Countries: CANADA, UNITED STATES Document ID: IK1201526  
 Availability: Revision: 2  
 Major System: ENGINE Created: 9/15/2025  
 Current Language: English Last Modified: 9/23/2025  
 Other Languages: NONE Author: Brandon Heisler  
 Viewed: 78

Title: Streamlined Design: Intake Resonator Eliminated on A26B Engines

Applies To: All A26B engines ESN 4600000 - 4699999, excluding those installed in the HX platform.

Figure #1

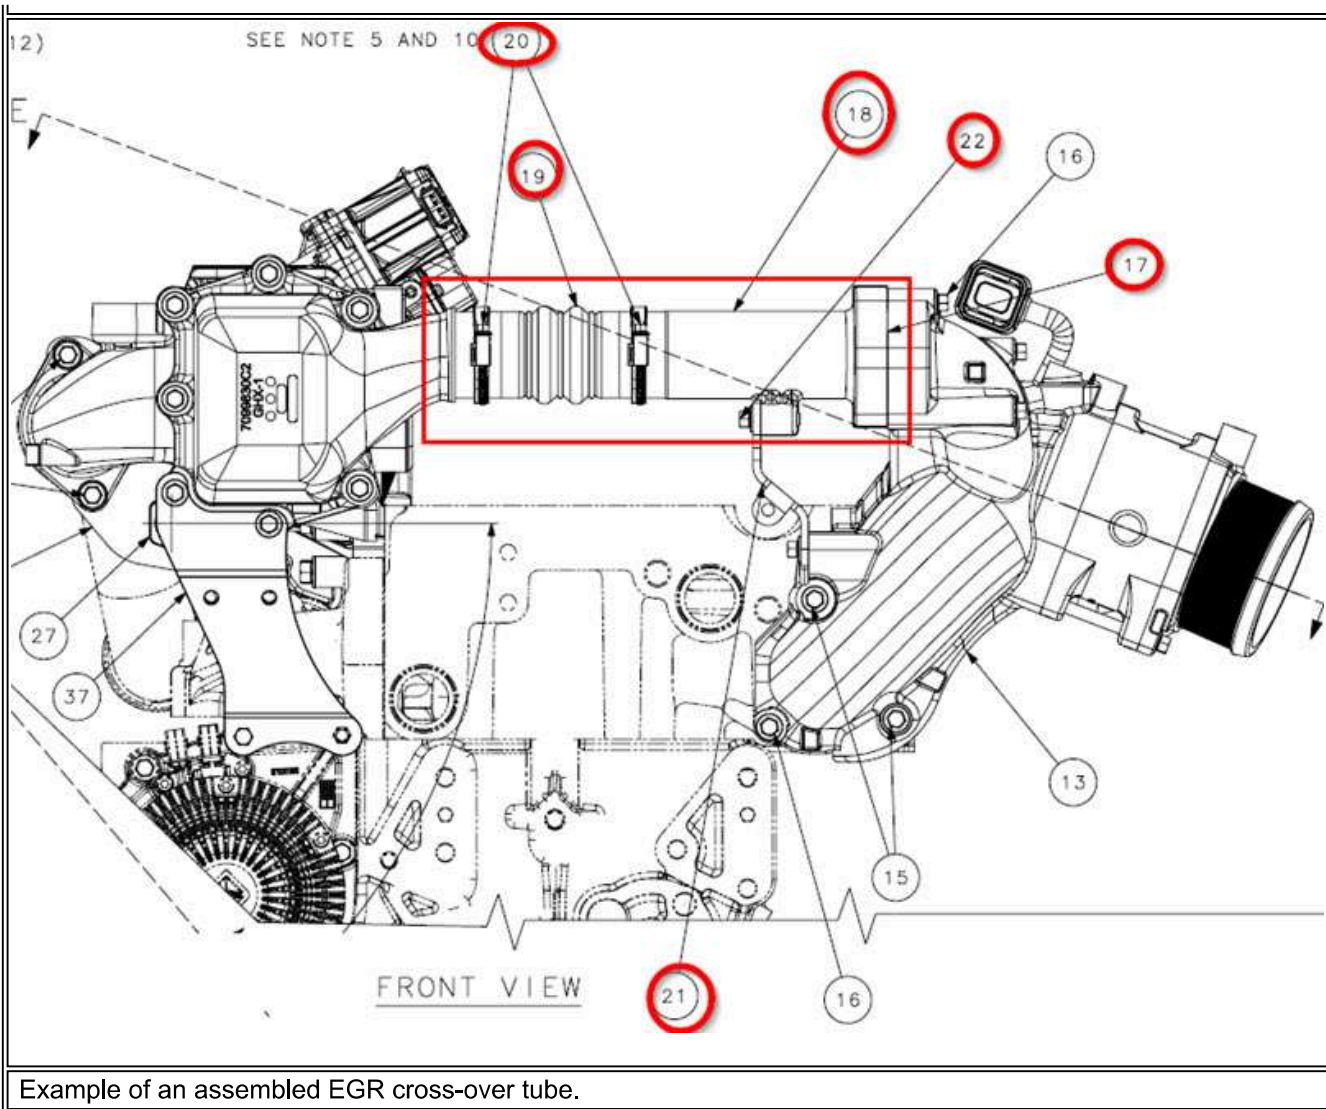
Step	Action	Decision
#3	<p>Confirm if the old resonator is fit for re-use. Inspect the resonator internals closely to check for black sticky substances. This is typically a fuel and soot mixture. See <a href="#">Figure #1</a> for an example:</p> <p>Is the resonator free from a black sticky substance?</p>	<p><b>Yes.</b></p> <p>Re-use the resonator and continue with repairs/replacements as needed.</p>
		<p><b>No.</b></p> <p>Replace the resonator with the EGR cross-over tube. See the "<a href="#">Service Parts Information</a>" section for parts information. See <a href="#">Figure #2</a> for an installed view of the part.</p>

It is imperative to check for the black sticky substance in the EGR system and determine the cause of this issue. This substance is typically a mixture of fuel and soot, and can make its way between the valve and valve guides in the cylinder head, causing the valves to stick in the guides. This can cause misfires, valve bridges to fall off, and sticking valves.
